**Notification of a Decision taken by the Cabinet Member for
Regeneration, Environment and Housing**

Subject: Proposed waiting restrictions borough wide 2018 Batch 1 (statutory consultation)

Appendix A - Drawing Nos. Z27-660-01 – Z27-660-20

Appendix C – Revised Drawing Nos. Z27-660-03A, Z27-660-06A and Z27-660-14A

Drawing No.	Z27-660-03
Revision	-
Classification	CONSULTATION
Scale	1:500

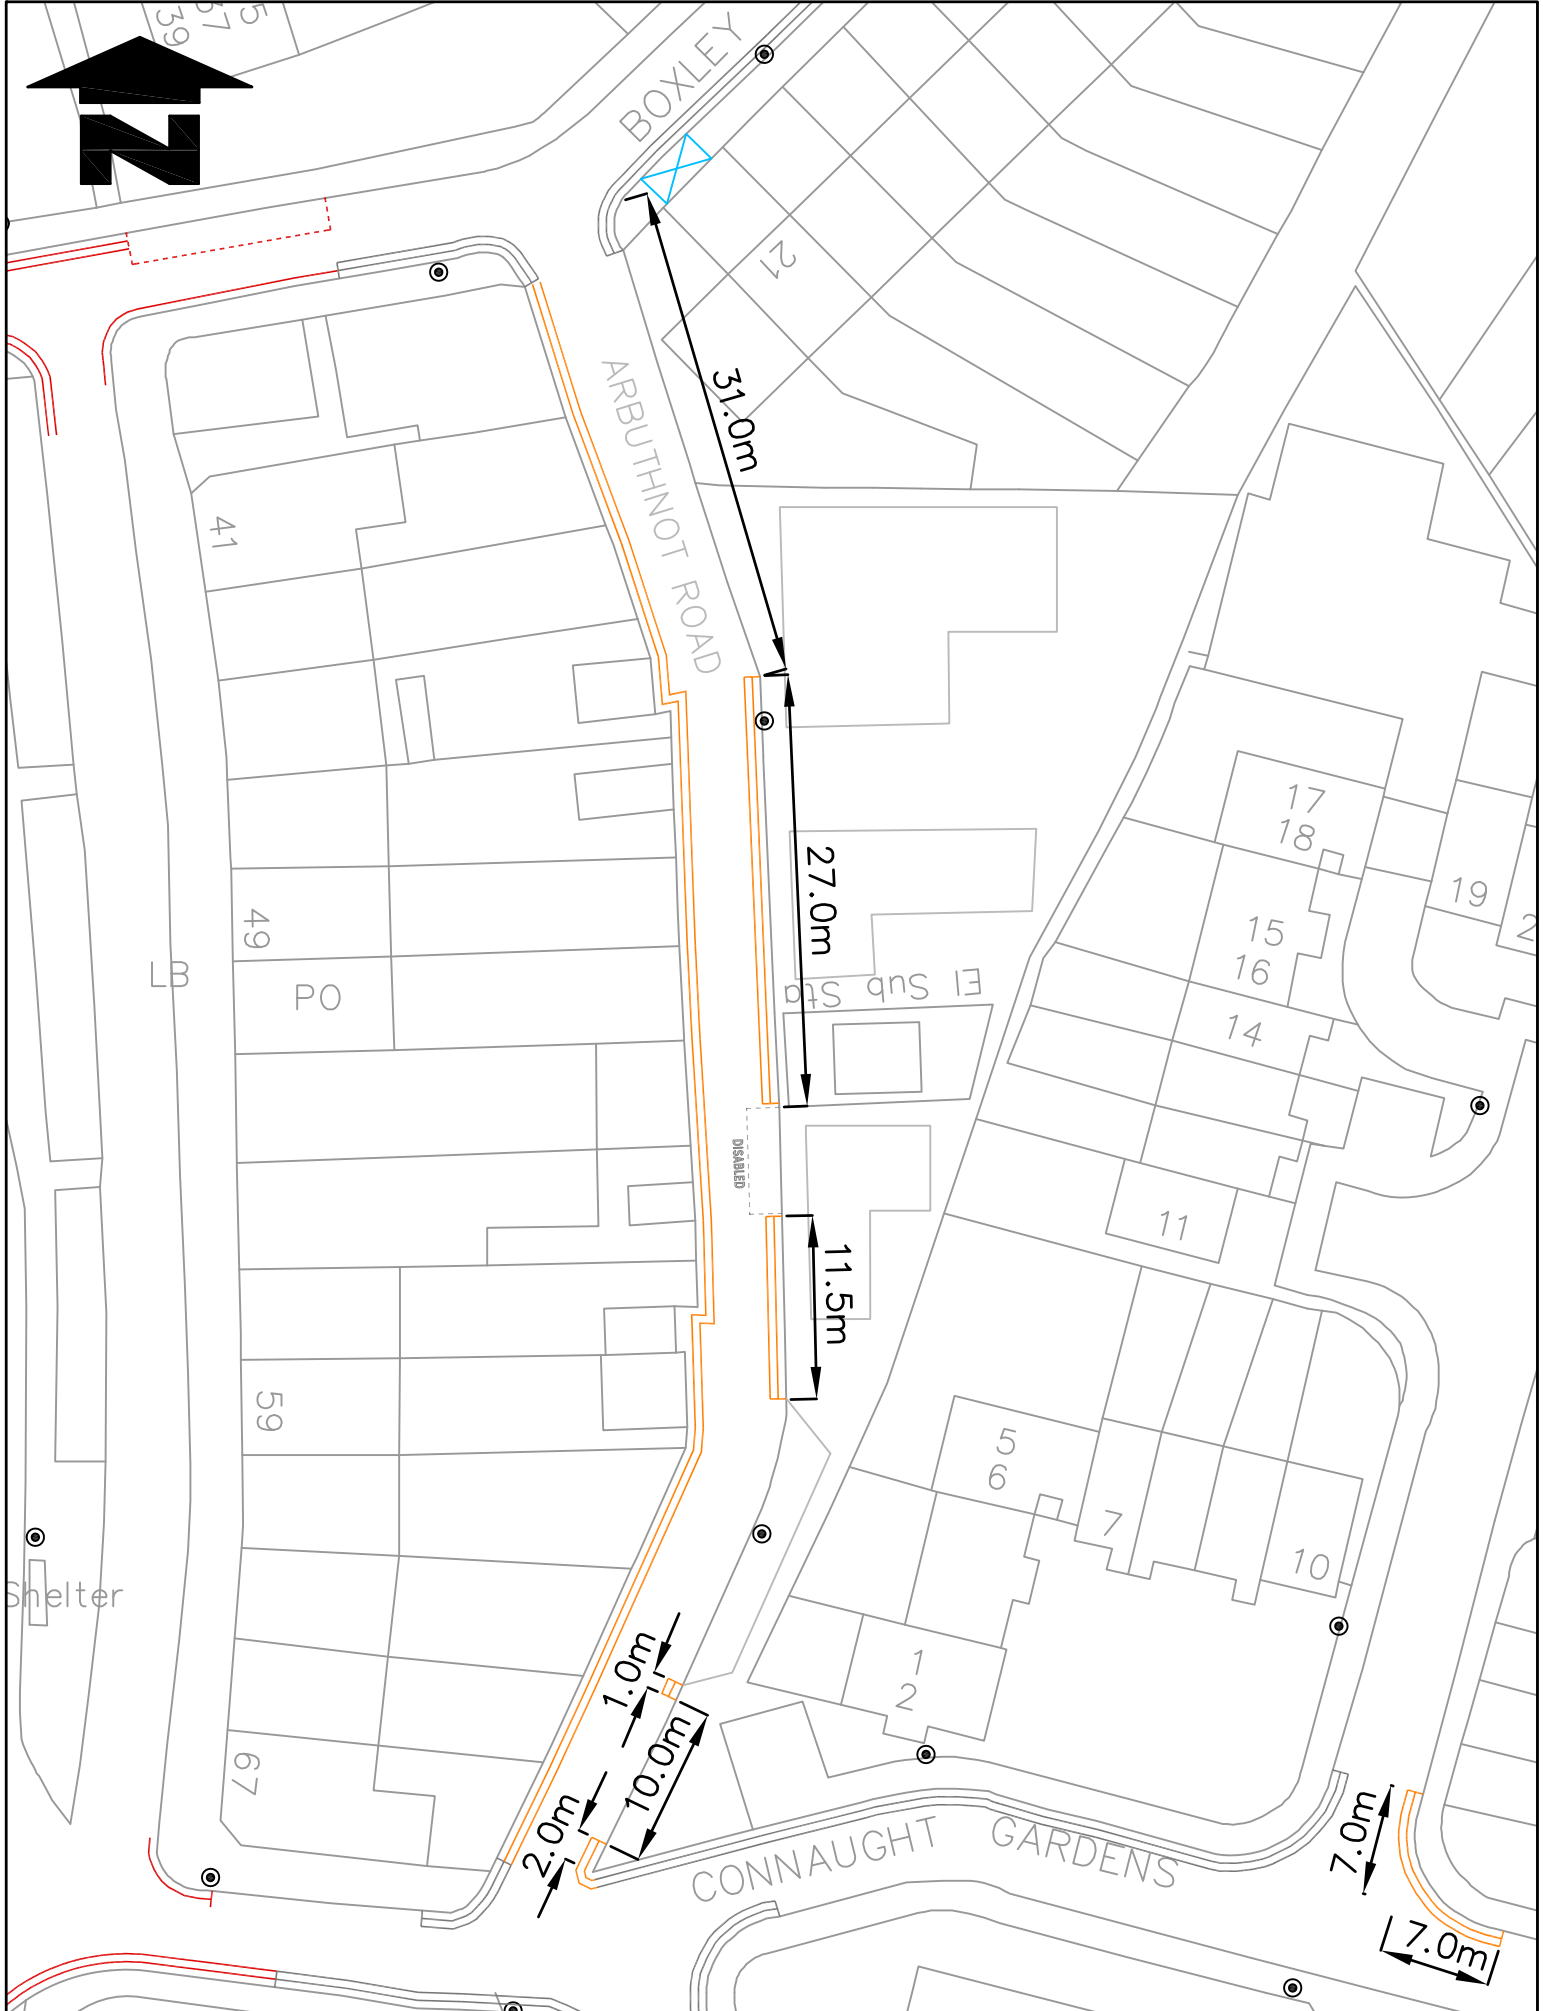
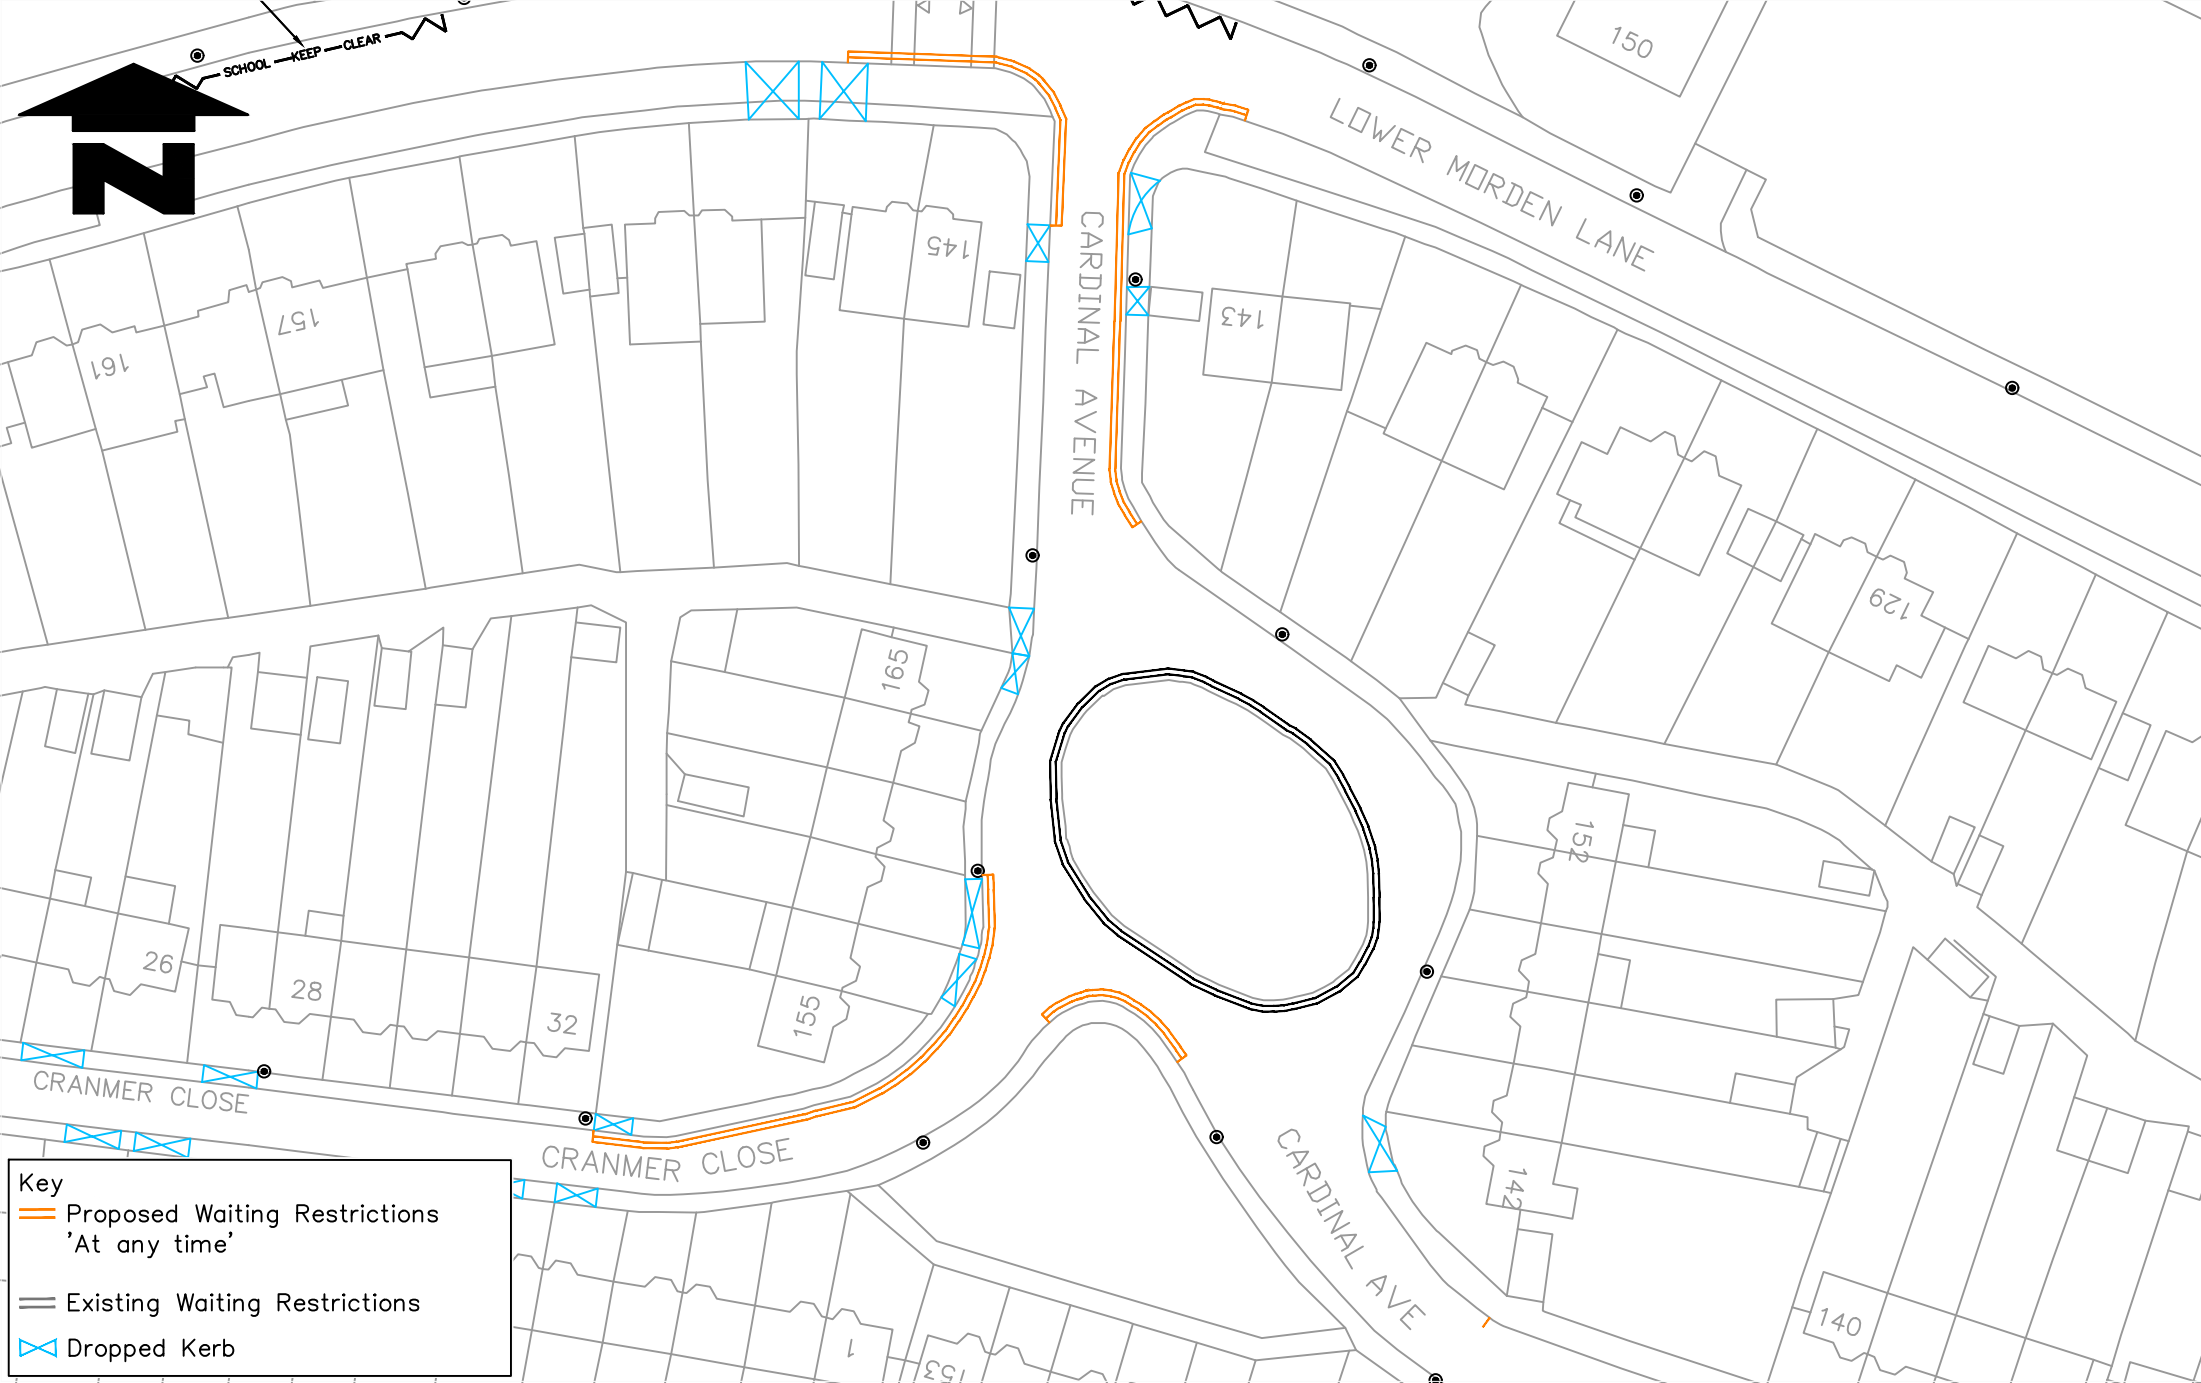
4.1 **Arbuthnot Road, SM4.** Proposal was in response to resident report of obstructive parking in Arbuthnot Road. 2 petitions were received, one in objection and one in support of the proposal.

4.2 The representation objecting to the proposal included a petition of consisting of 369 signatures 'against the proposed double yellow lines', however the majority were from a wide radius of surrounding roads, but included 12 properties based on the parade of shops

- 4.4 The carriageway width of Arbuthnot Road is not sufficient to accommodate parking on both sides of the carriageway, further the western side of the road has accesses to the rear off-road areas for the parade of shops / properties on St. Helier Road, it is this side of the carriageway the proposal aims to keep clear. The Council has a statutory duty to ensure safety and access for moving traffic on the public highway, especially refuse vehicles and emergency service vehicles and this takes priority over loss of parking. The restrictions will help to improve safety for all road users and will ensure that access is maintained at all times.

I am making this Petition Representation Against the proposed Double Yellow Lines WR2018b1 on St Helier Avenue Service Road / Arbuthnot Road & Connaught Gardens. This petition consists of a paper one, and Online at Change.org. Background and Issues :

- 4.5 However, giving consideration to the representations / petitions received and appreciation to the existing parking pressure expressed by the community the extents of the waiting restrictions are proposed on the western side of the carriageway only to maintain clear access through the road, especially for waste collection services as well as provide clear access for emergency services should the need arise. The revised proposal can be found in appendix C.

Drawing No.	Z27-660-04
Revision	-
Classification	CONSULTATION
Scale	1: 500

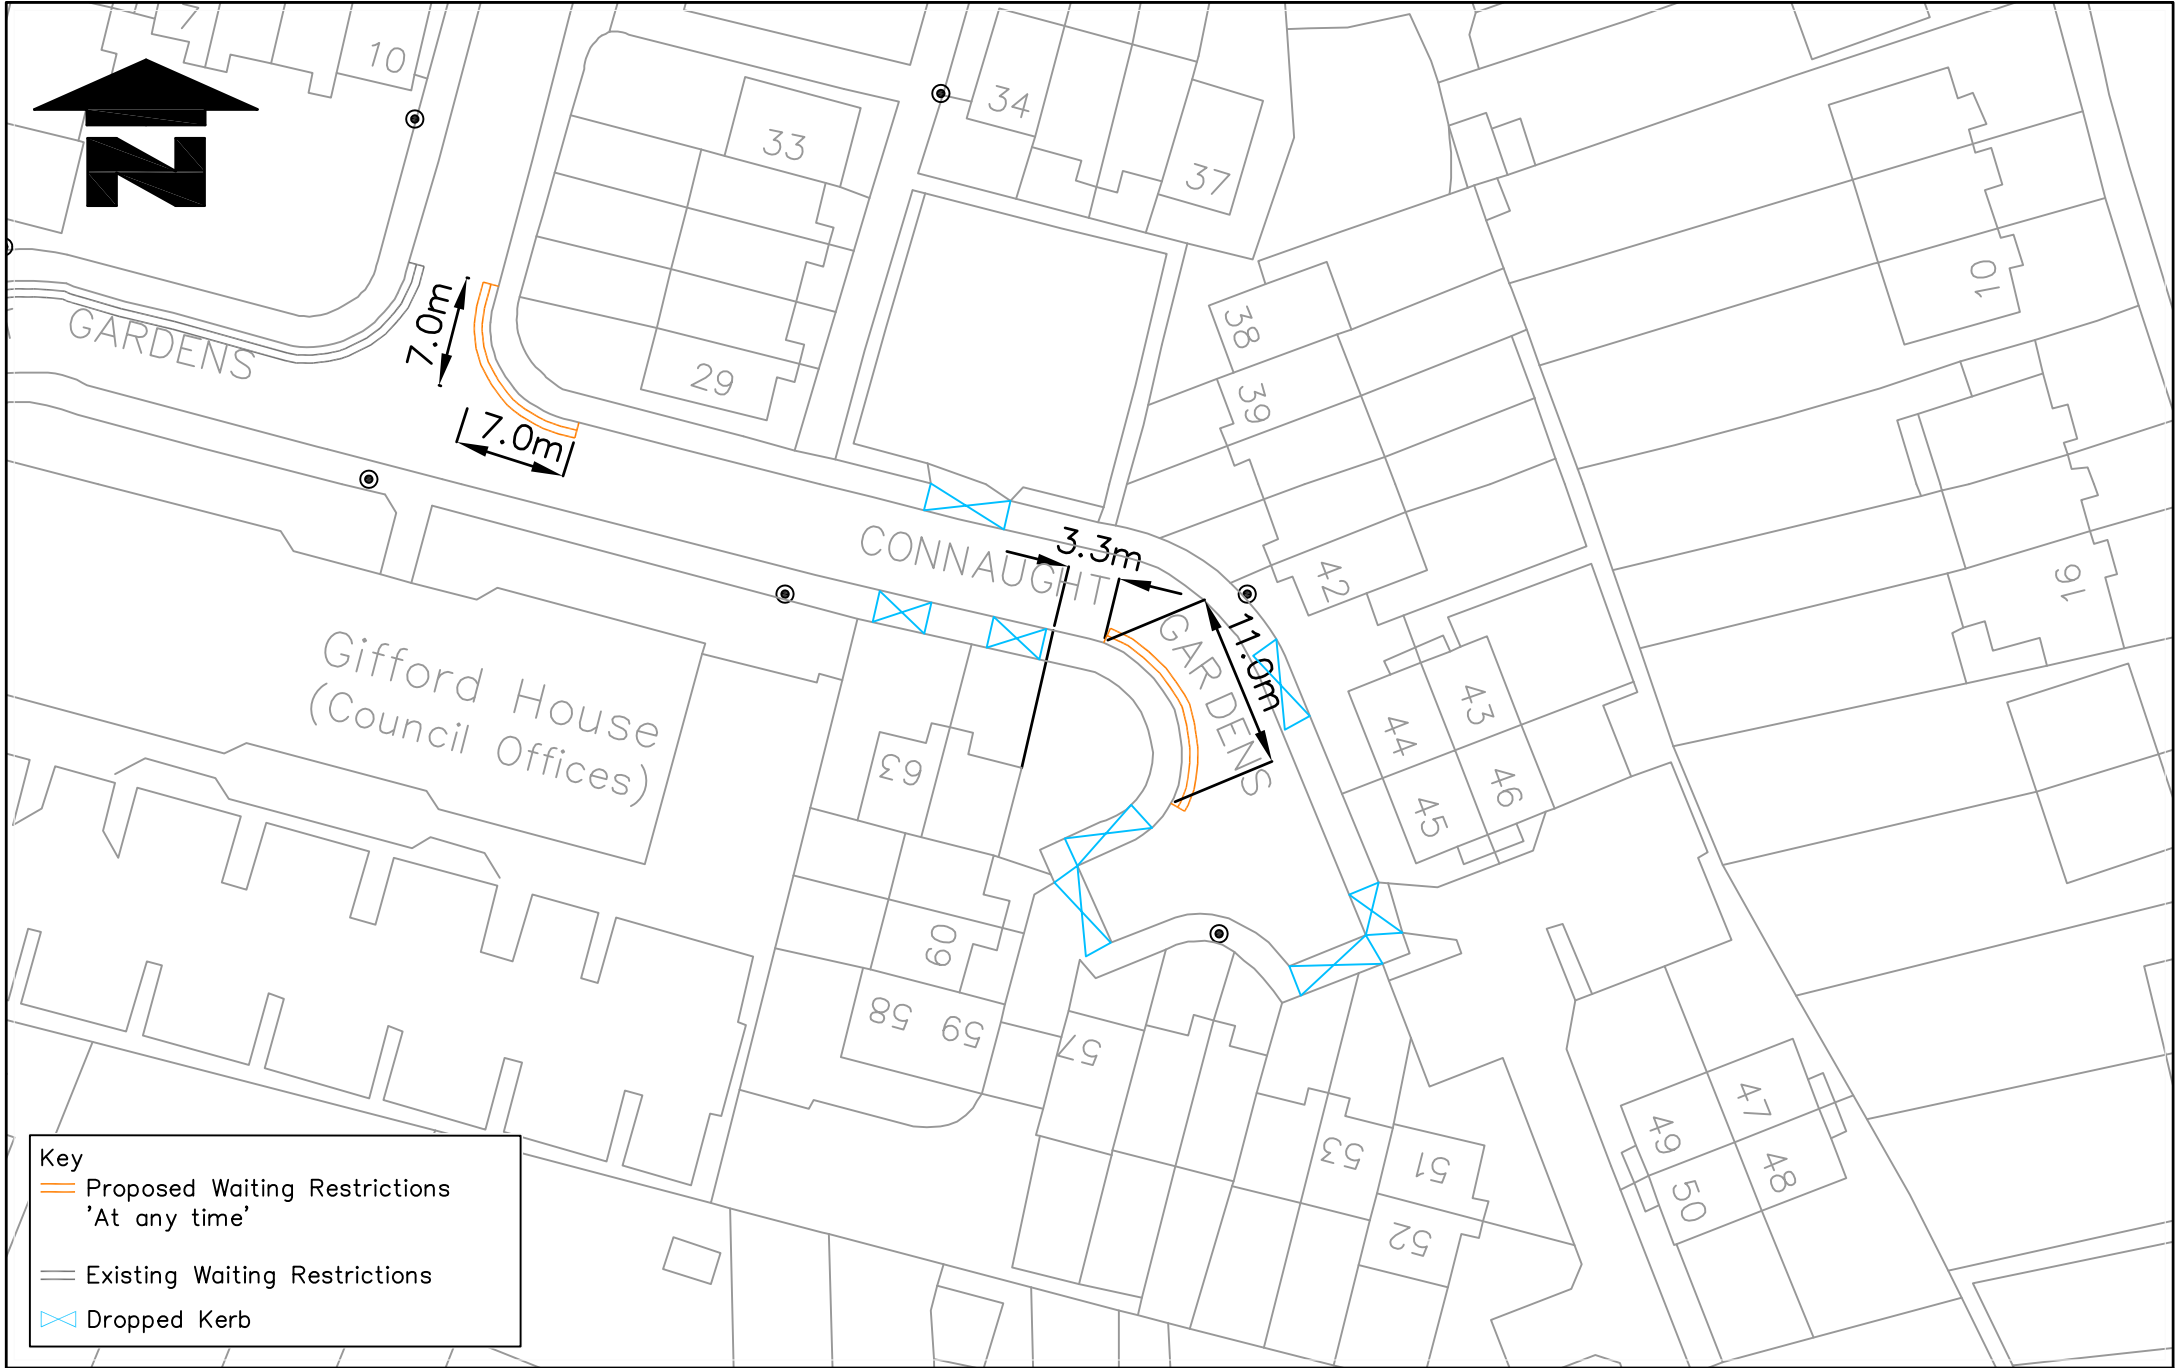
- 4.11 **Connaught Gardens, SM4.** 1 representation received with a conditional objection to the inclusion of an ambulance parking bay. The ambulance bay has been removed from the proposal and will proceed with the waiting restriction only.

I would like to raise an objection on the above reference in Connaught Gardens Drawing No. Z27-660-04.
